W3F1-2011-0067

SUBJECT: License Amendment Request
Proposed Change to Technical Specification 3/4.7.4 Table 3.7-3, "Ultimate Heat Sink Minimum Fan Requirements Per Train"
Waterford Steam Electric Station, Unit 3
Docket No. 50-382
License No. NPF-38

Analysis of Proposed Technical Specification Change

Proposed Technical Specification Changes (mark-up)

Figure 1: Top View of WCT ACCW Inlet Flow Diagram @ Design Flow Rate

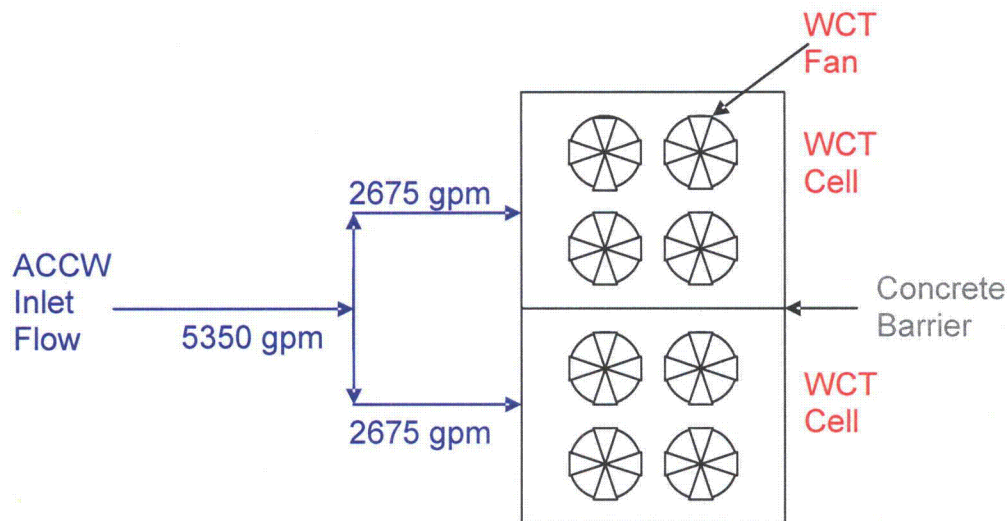
As discussed above, if an entire cell were inoperable, the Auxiliary Component Cooling Water (ACCW) entering this cell would not be cooled by forced evaporative cooling. Rather, this ACCW flow would be cooled by natural draft cooling which is significantly less effective than forced evaporative cooling. Based on the Zurn Natural Draft Thermal Performance Curves, the natural draft cooling range is ~3°F at design conditions. Whereas, the cooling range for the evaporative cooling is ~23°F at design conditions. Therefore, if one cell was inoperable, the entering ACCW flow would only be cooled about 3°F, which, when mixed in the WCT basin, would unacceptably reduce the capacity to remove heat from the CCW system. Therefore, the analysis has been revised to credit an equal number of fans in each cell, such that the Cooling Tower Institute (CTI) Code ATC-105 methodology is valid for determining the impact on out of service fans.

TS Table 3.7-3, which indicates the number of WCT fans operable for a given wet bulb temperature, will be revised. The fan requirements will be specified per cell, rather than per tower. The sentence in Note ** will be revised to read "With any WCT fan(s) out of service in any cell, covers must be in place on the out-of-service fan(s) or the entire Wet Cooling Tower must be declared out of service." Additionally, Note (2) will be added to read "With any WCT cell(s) out of service, the entire associated Wet Cooling Tower must be declared out of service."
